STAFF REPORT
(One-Step Final Plat)

CASE NUMBER: SUB 2005-41 -- REGENCY PARK THIRD ADDITION

LOCATION: South of 29th St. North, West of Greenwich

VICINITY MAP

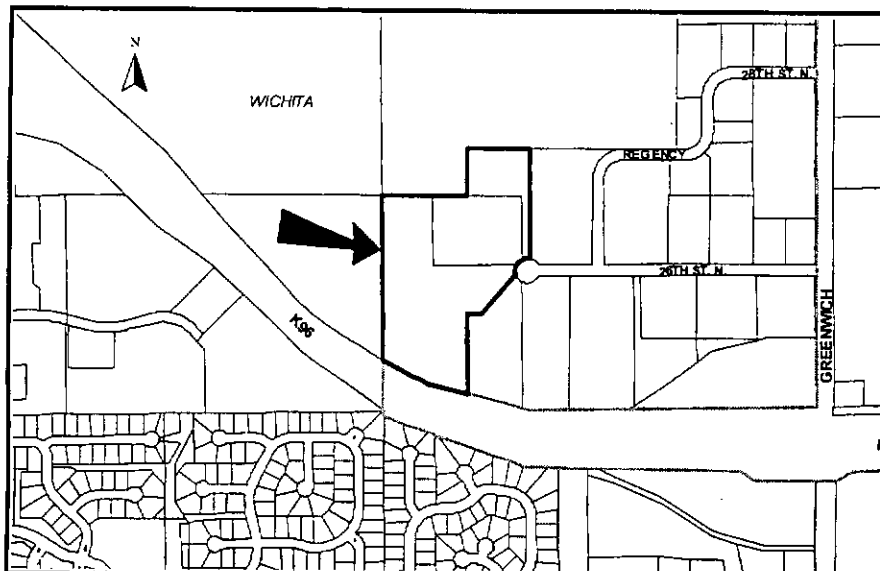
- J. GIS needs to comment on the plat's street names. 26th St. Cir needs to be changed to 26th Cir N.
- K. The Applicant is reminded that a platting binder is required with the final plat. Approval of this plat will be subject to submittal of this binder and any relevant conditions found by such a review.

- L. Applicant needs to denote lot dimensions around east cul-de-sac.
- M. The plat's text shall include language that a drainage plan has been developed for the plat and that all drainage easements, rights-of-way, or reserves shall remain at established grades or as modified with the approval of the applicable City or County Engineer, and unobstructed to allow for the conveyance of stormwater.
